DILLMAN ROAD WWTP SITE SAFETY AND PROCESS IMPROVEMENTS

**CITY OF BLOOMINGTON UTILITIES
DILLMAN ROAD WWTP SITE SAFETY
AND PROCESS IMPROVEMENTS**

Addendum No. 1

TYLin | Greeley and Hansen Water Solutions
November 15, 2024

PROJECT NO.: 0593W
 DWG: **M7**
 SHEET: 23 OF 62
 DATE: OCTOBER 2024 REV: 1

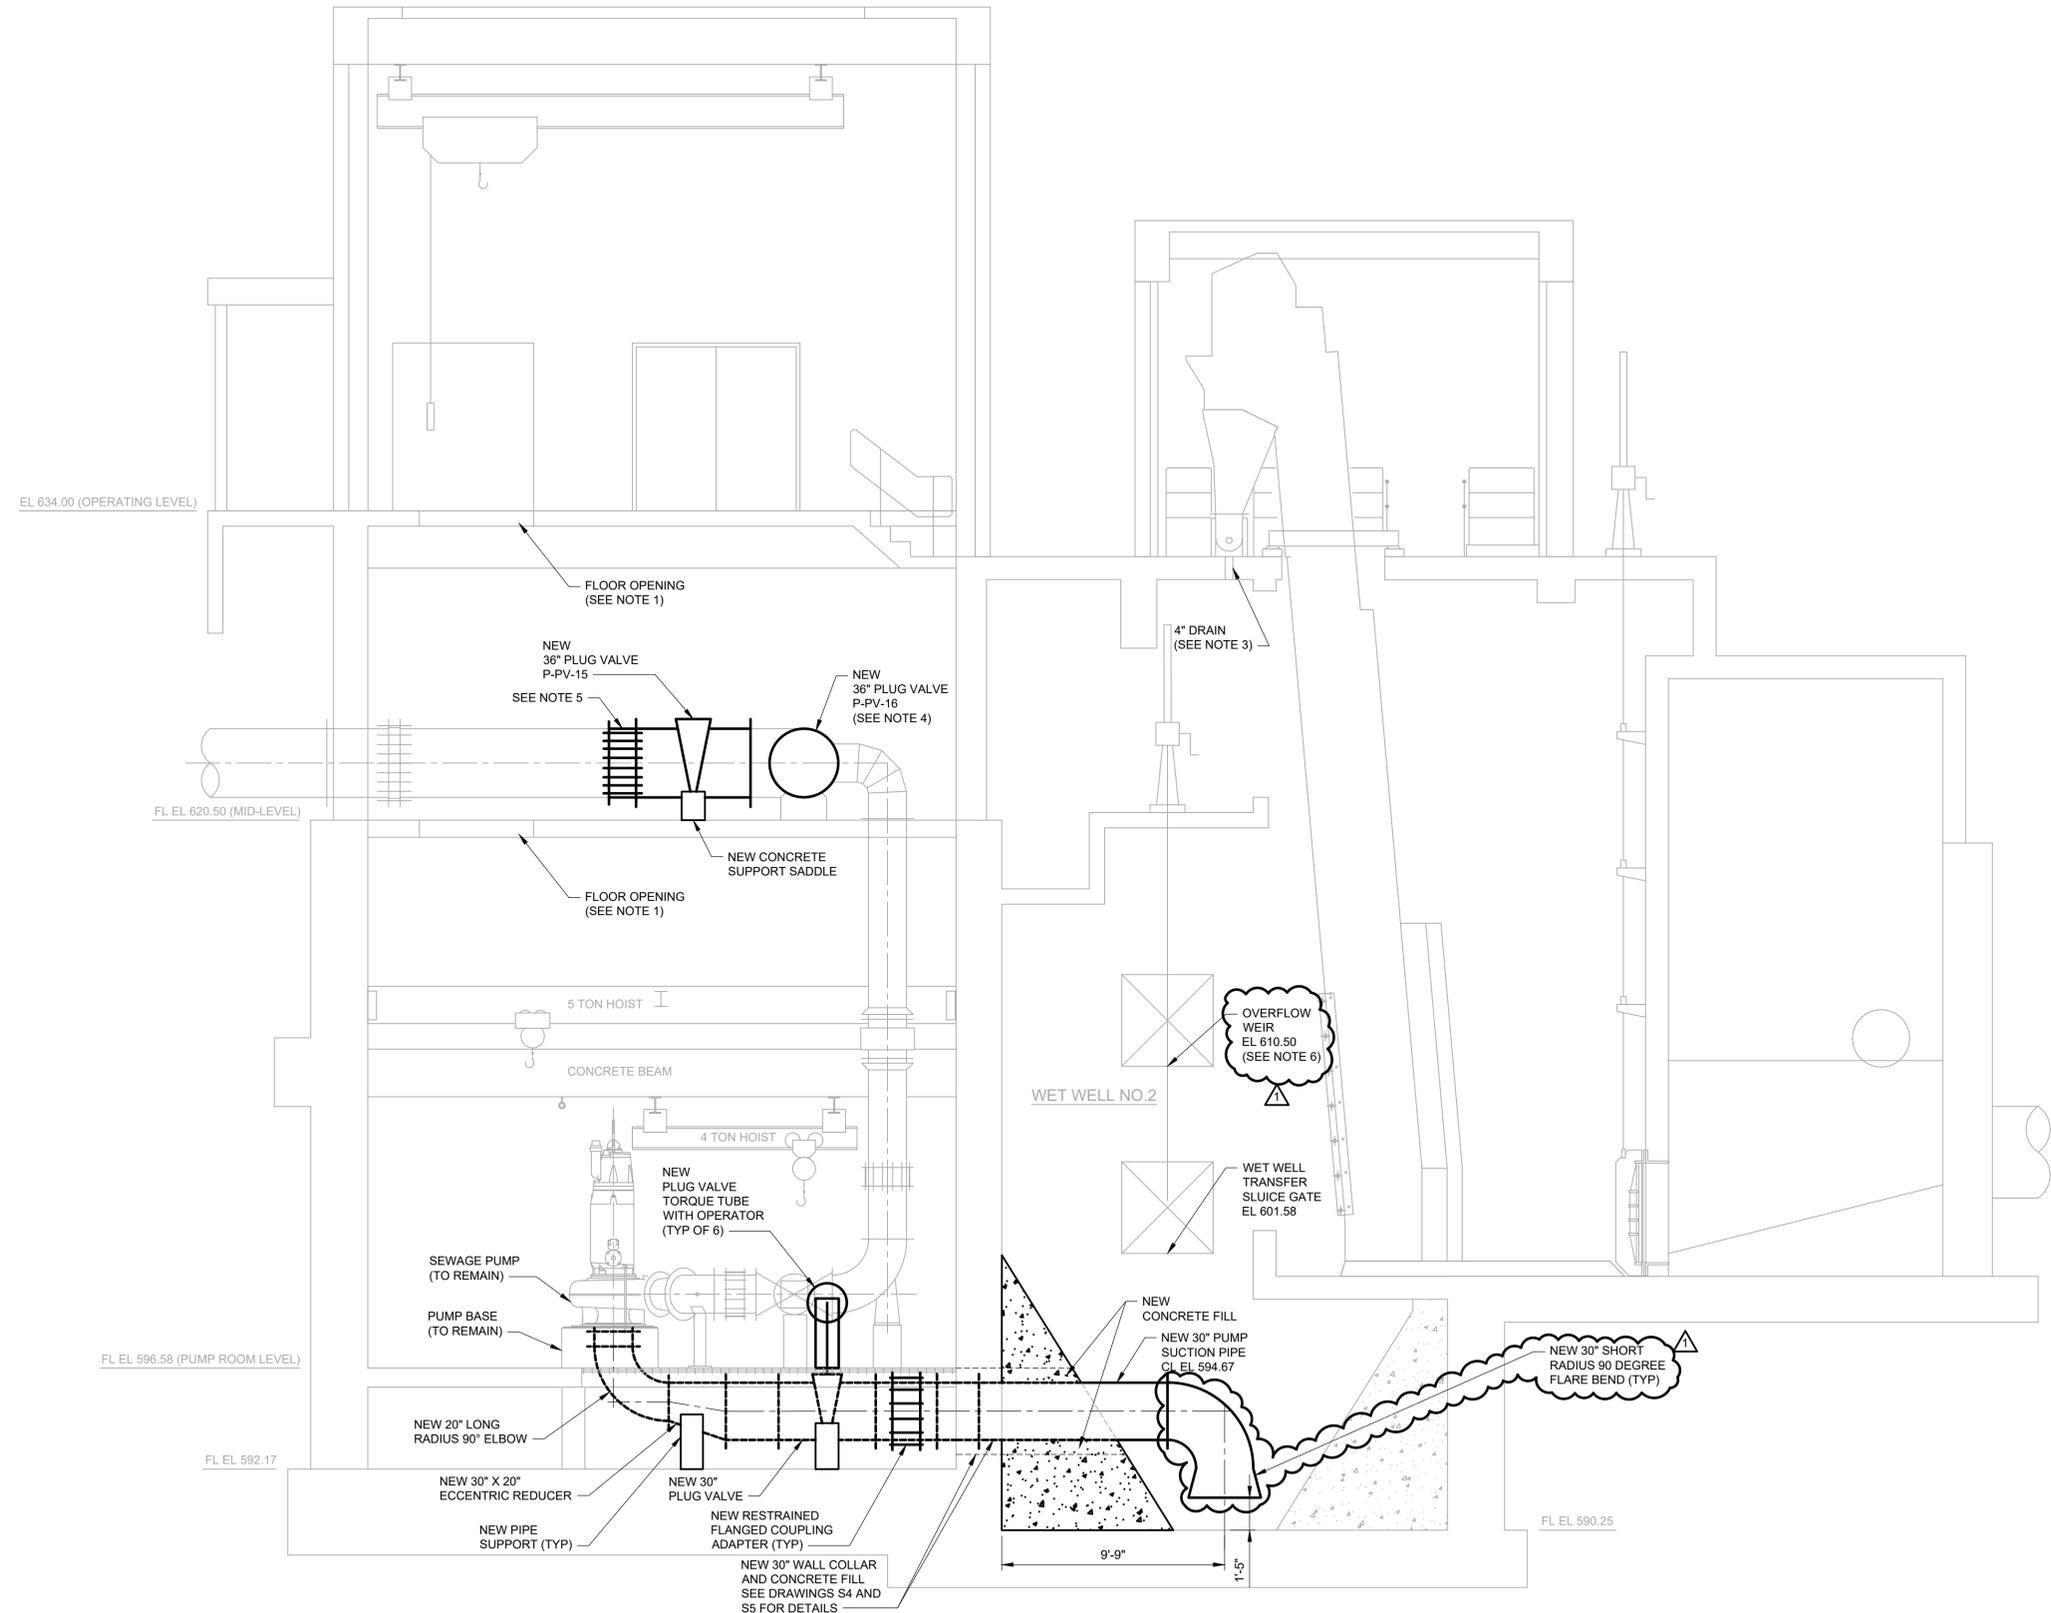
9. Question: Per the Pipe Schedule, the pump suction lines are to be ductile iron pipe. Drawing M7 indicates a "30" Short Radius, smooth 90' bend with a 38" Bellmouth "welded" to bottom? Based on this, should this suction piping be Carbon Steel (CS) Piping? It appears to be drawn on the bid drawings as CS. The fittings do not appear to be standard DIP fittings?

5. Question: Reference Sheet M7. This drawing calls out a 30" Wall Collar that appears to extend from the inside of the Pump Building to the outside edge of the fillet in the Wet Well (approx. 7' 6" in length). The plan view on Sheet M5 does not show this extended wall collar. Sheet S4 calls out a new wall pipe. Is this intended to be a Wall Casting? The detail on Sheet S4 shows a pipe passing through a wall sleeve with no water collar so we are assuming this detail requires Link Seal? Does the Concrete Fillet get poured directly over the new pipe that extends into the Wet Well? Please provide more detail for this pipe penetration so it is clear what is required.

Answer: Pump suction to be ductile iron per pipe schedule. Elbow and bellmouth to be special DIP fitting - Short Radius 90 Degree Flare Bend. See attached revised Drawings M5 and M7.

Answer: Pipe section to be wall collar that extends to outside edge of fillet as shown in M7. See Revised Drawings S4 and S5. Concrete fillet to be poured directly over new wall collar pipe.

DESIGNED: DGP
CHECKED: GJK
APPROVED: LWS
DATE: 12-22-71
SHEET GF-11
93 OF 190
PROJECT 7409

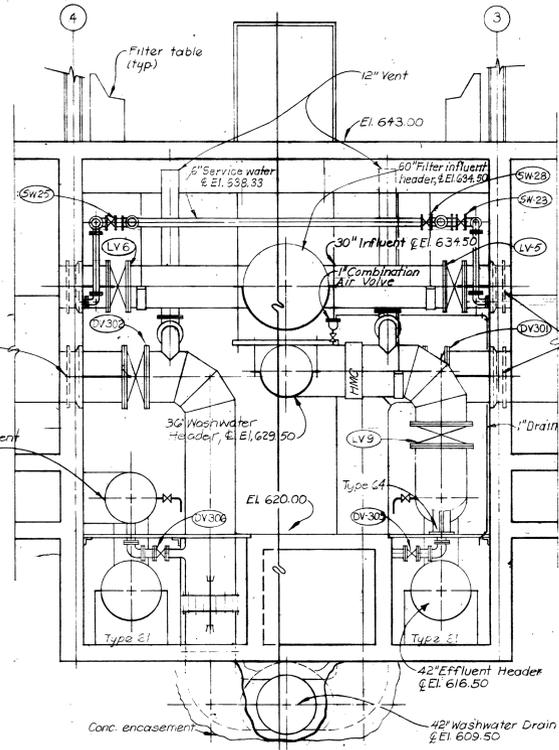
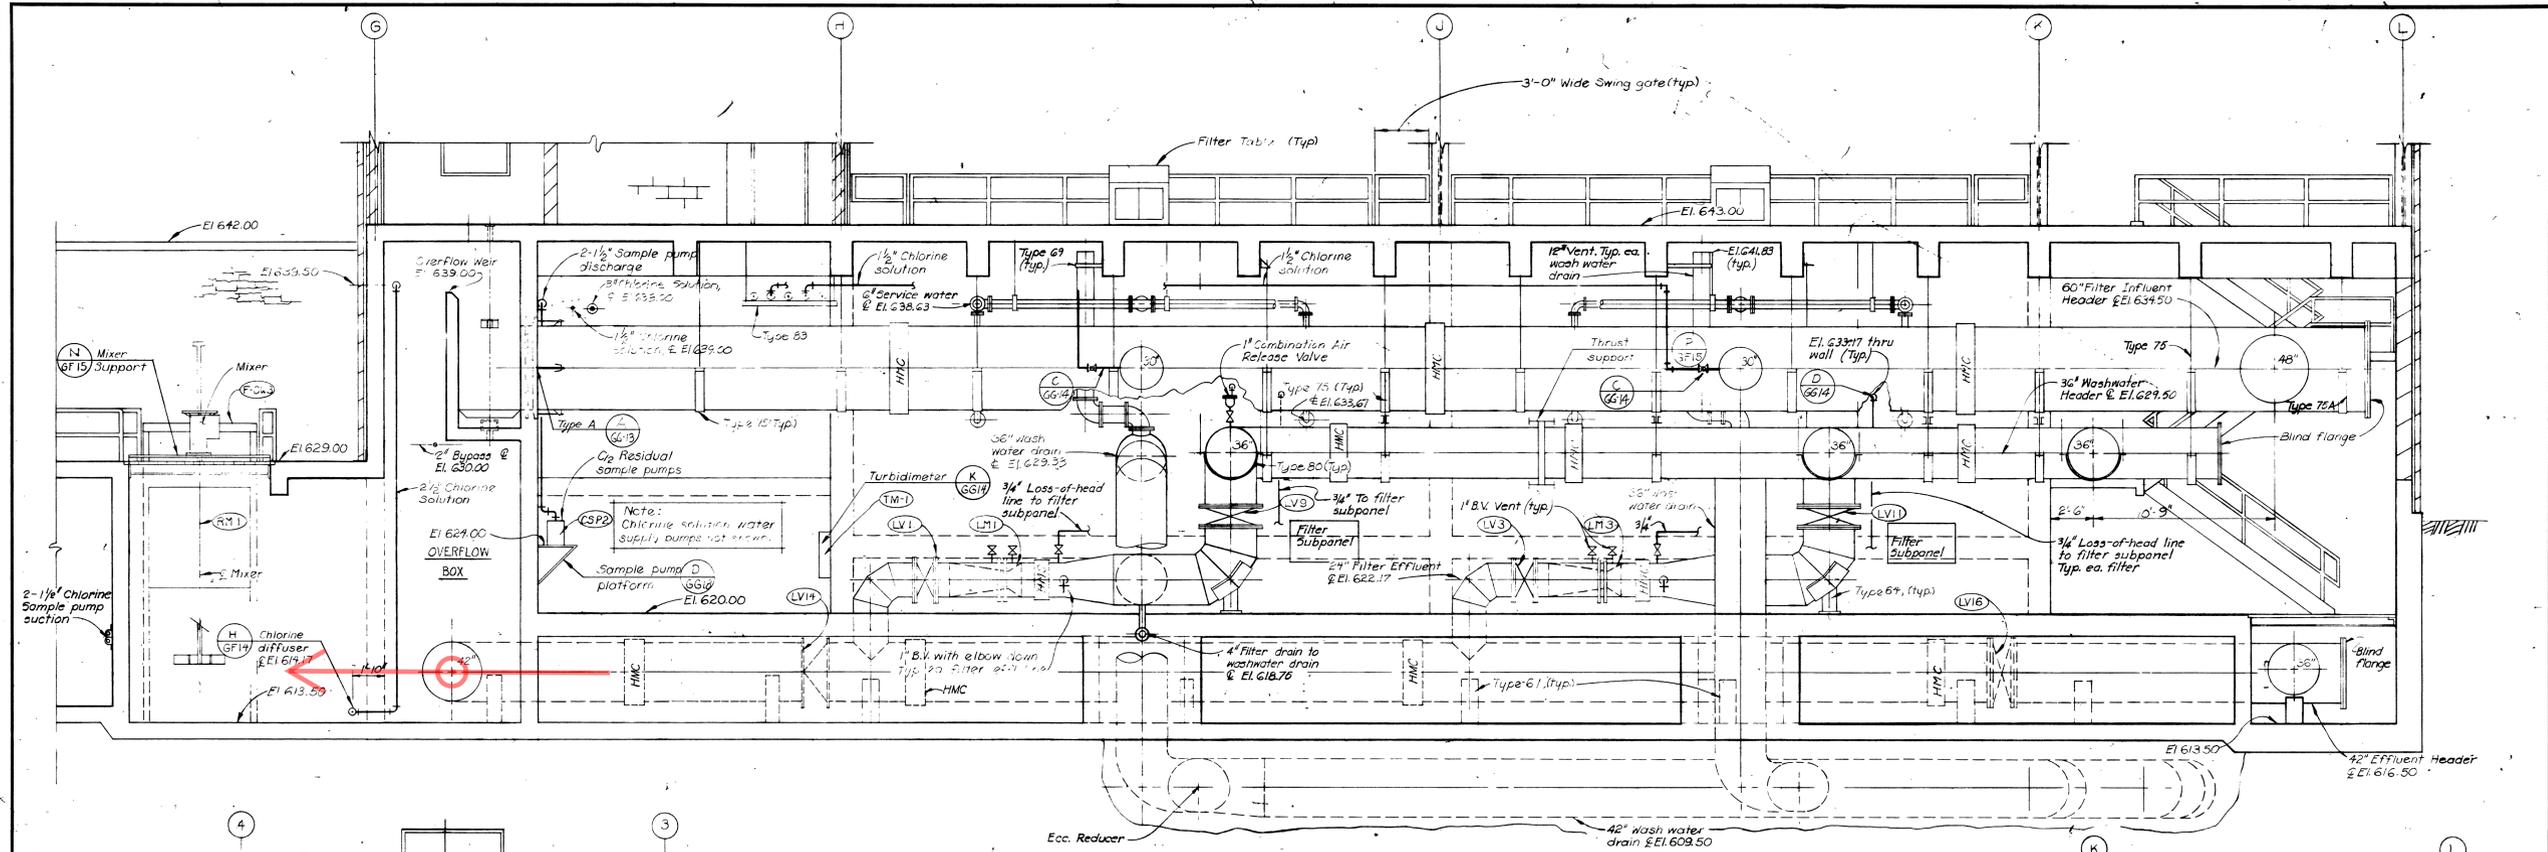
6. Question: Reference Sheet M10. This drawing calls out a Temporary Cofferdam that is "L" shaped. Are there 2 channels being isolated in this configuration? Is it acceptable to use a single steel plate (not an L shape) on the upstream side of each gate for isolation? Does the flow enter into the Mixing Well from the floor or wall? Is there a better detail of this area that can be provided? Please advise.

Answer: Temporary cofferdam to isolate two channels. Single steel plate is acceptable for isolation. Filter effluent is discharged via two (2) 42" filter effluent pipes. Flow is discharged into overflow box that is connected to the mixing well. See attached record drawings Sheet GF-11 Basement Piping Plan and GF-12 Piping Sections.
